IOWA DEPARTMENT OF TRANSPORTATION

Ref No. 521.1

Subject Method's Memo No. 116 (Correction to Figure 6.5.2.5 in 6.5 Abutments of the Bridge Design Manual)

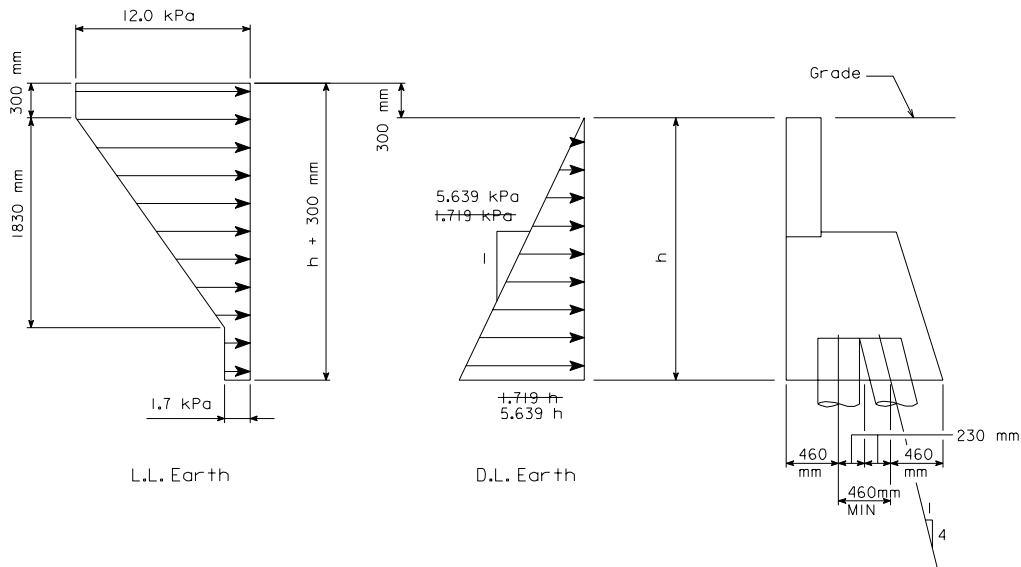
The following error has been found in Figure 6.5.2.5 metric version in section "6.5 Abutments" of the Bridge Design Manual. The soil pressure conversion from English to metric should be 5.639 kPa / m of height instead of the 1.719 kPa / m of height that was shown. Please review any design calculations where this values has been used and make the appropriate correction. See corrected figure below.
